LMC South Park Masterplan (LAND-2020-00029/ 00030)*Comment Response Matrix – City Council Questions/Comments*

LMC South Park Masterplan (LAND-2020-00029/ 00030)

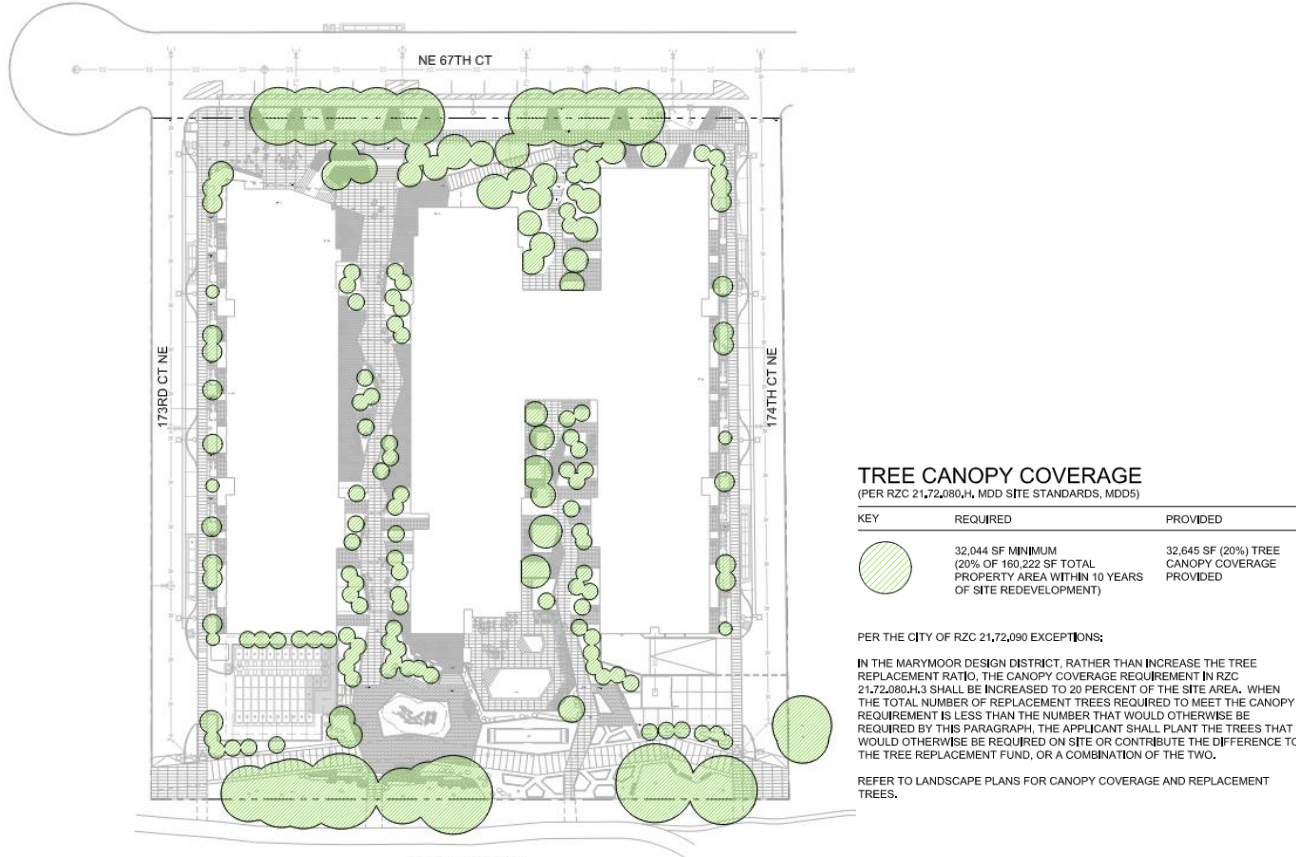
<p>7. Councilwoman Anderson— Live/work Units</p>	<p><u>Subject</u> Live/work Units</p> <p><u>Summary of Comments</u> How many live/ work units will there be?</p> <p><u>Response</u> Thirteen live/work units are included in the project. Eleven are located on the ground floor of the artwalk and two are located at the intersection of NE 67th Court and 174th Avenue NE.</p>	<p>Closed 7/27/2021</p>
<p>8. Councilwoman Kritzer—Existing Businesses</p>	<p><u>Subject</u> Existing Businesses</p> <p><u>Summary of Comments</u> Are there businesses currently there? What is the plan for existing businesses and what is the City doing to support them if they have to move?</p> <p><u>Response</u> All existing tenants have all relocated. The City does offer services to help support finding new locations, creating affordable commercial via incentives and support with lease negotiations, loans and grants.</p>	<p>Closed 7/27/2021</p>

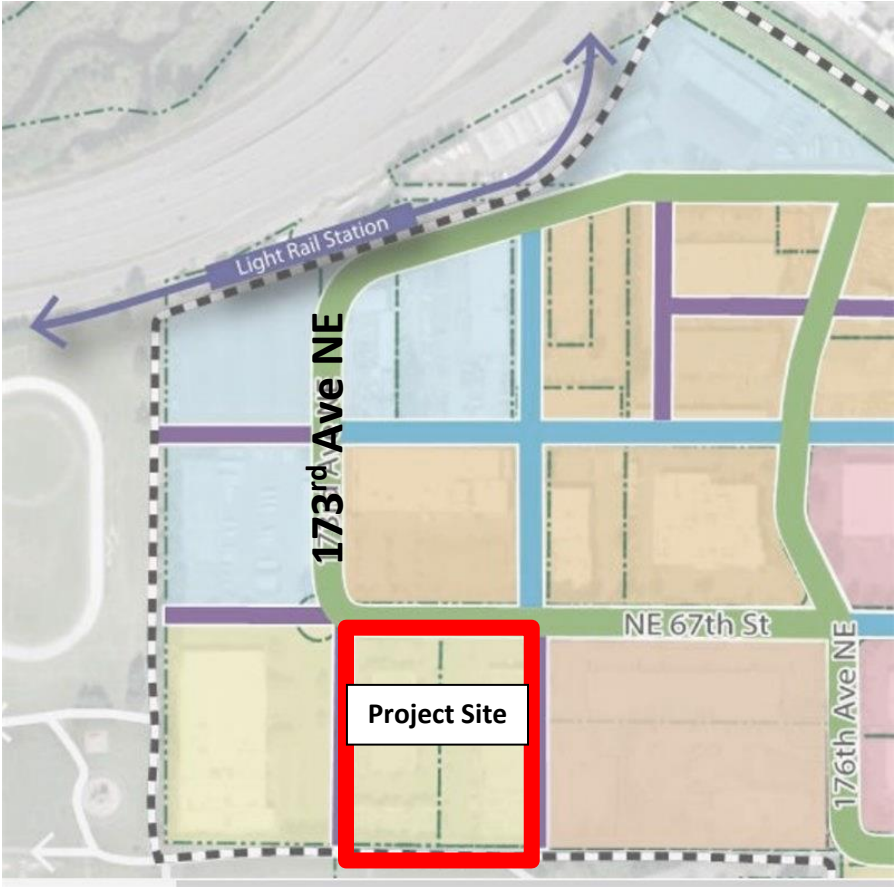
10. Councilwoman Kritzer-- Trees	<p><u>Subject</u> Trees</p> <p><u>Summary of Comments</u> Provide an overview of the plan for existing trees and replacement trees.</p> <p><u>Response</u> A Tree Health Assessment dated January 22, 2021 was prepared by Tree Solutions Inc. The trees on site were examined and 93 trees were observed to be “significant” as defined in Redmond Zoning Code (RZC) 21.87, as “Any healthy tree six inches in diameter at breast height (d.b.h.), or any tree four inches in diameter at breast height (d.b.h.)” Of the 93 significant trees, 11 will be impacted by retained, however impacted trees do not count as retained trees, and no trees will be retained. A tree canopy coverage of 20% of the site area within ten years of the site redevelopment will be planted on site, which includes a total of 159 trees on site. The Tree Canopy Coverage can be found on L001 of the 15. Plan Set and is also shown below for reference.</p>	Closed 7/27/2021

Issue	Summary & Response	Status						
	 <p>TREE CANOPY COVERAGE (PER RZC 21.72.080.H, MDD SITE STANDARDS, MDD5)</p> <table border="1"> <thead> <tr> <th>KEY</th><th>REQUIRED</th><th>PROVIDED</th></tr> </thead> <tbody> <tr> <td></td><td>32,044 SF MINIMUM (20% OF 160,222 SF TOTAL PROPERTY AREA WITHIN 10 YEARS OF SITE REDEVELOPMENT)</td><td>32,645 SF (20%) TREE CANOPY COVERAGE PROVIDED</td></tr> </tbody> </table> <p>PER THE CITY OF RZC 21.72.090 EXCEPTIONS:</p> <p>IN THE MARYMOOR DESIGN DISTRICT, RATHER THAN INCREASE THE TREE REPLACEMENT RATIO, THE CANOPY COVERAGE REQUIREMENT IN RZC 21.72.080.H.3 SHALL BE INCREASED TO 20 PERCENT OF THE SITE AREA. WHEN THE TOTAL NUMBER OF REPLACEMENT TREES REQUIRED TO MEET THE CANOPY REQUIREMENT IS LESS THAN THE NUMBER THAT WOULD OTHERWISE BE REQUIRED BY THIS PARAGRAPH, THE APPLICANT SHALL PLANT THE TREES THAT WOULD OTHERWISE BE REQUIRED ON SITE OR CONTRIBUTE THE DIFFERENCE TO THE TREE REPLACEMENT FUND, OR A COMBINATION OF THE TWO.</p> <p>REFER TO LANDSCAPE PLANS FOR CANOPY COVERAGE AND REPLACEMENT TREES.</p>	KEY	REQUIRED	PROVIDED		32,044 SF MINIMUM (20% OF 160,222 SF TOTAL PROPERTY AREA WITHIN 10 YEARS OF SITE REDEVELOPMENT)	32,645 SF (20%) TREE CANOPY COVERAGE PROVIDED	
KEY	REQUIRED	PROVIDED						
	32,044 SF MINIMUM (20% OF 160,222 SF TOTAL PROPERTY AREA WITHIN 10 YEARS OF SITE REDEVELOPMENT)	32,645 SF (20%) TREE CANOPY COVERAGE PROVIDED						
<p>11. Councilwoman Padhye— Accessibility to Light Rail</p>	<p><u>Subject</u> Accessibility to Light Rail</p> <p><u>Summary of Comments</u> The project will be approximately 0.25 miles from the future Light Rail station, how will the Light Rail be accessible regardless of mobility abilities?</p> <p><u>Response</u></p>	<p>Closed 7/27/2021</p>

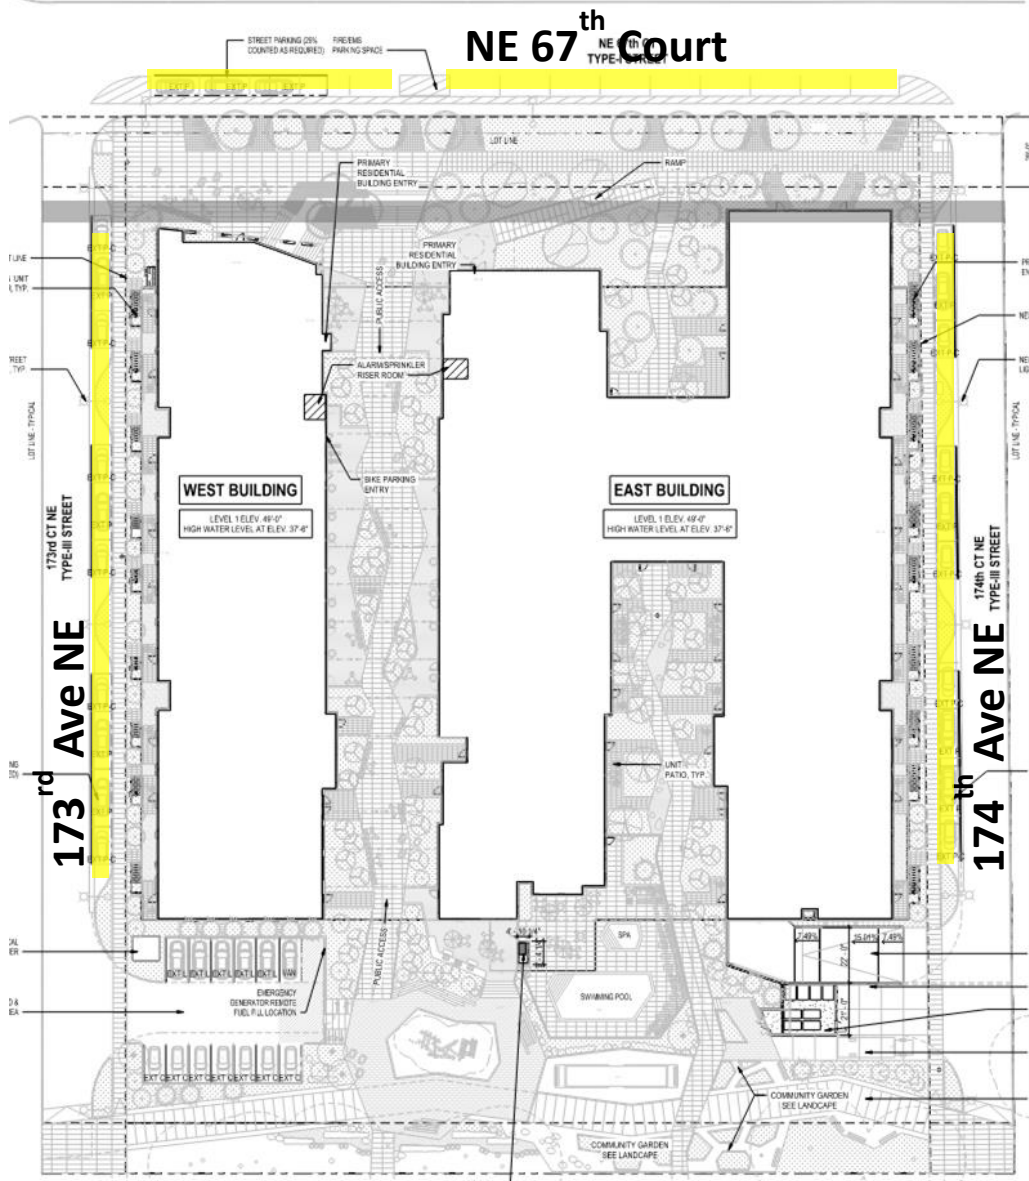
15. Councilwoman Anderson— LEED Certification	<p><u>Subject</u> LEED Certification</p> <p><u>Summary of Comments</u> Has there been a conversation about pursuing LEED Certification?</p> <p><u>Response</u> LEED Certification is not required by the Redmond Zoning Code (RZC). The RZC does offer development incentives if LEED certification is pursued, as part of the Green Building Incentive Program. However, the Green Building Incentives are not being pursued as a part of this project. In addition, requests of both the applicant and the City must be balanced in terms of development and public benefits. If the City asked for LEED Certification, it would potentially lead to less public benefits.</p> <p>Bridge amendments to the RZC are currently being worked on. Incentives in the Marymoor Design District (MDD) have been utilized already, and staff is currently in the process of amending the MDD Incentives Program and will include LEED Certification silver, gold, and platinum requirements.</p>	Updated 8/17/2021
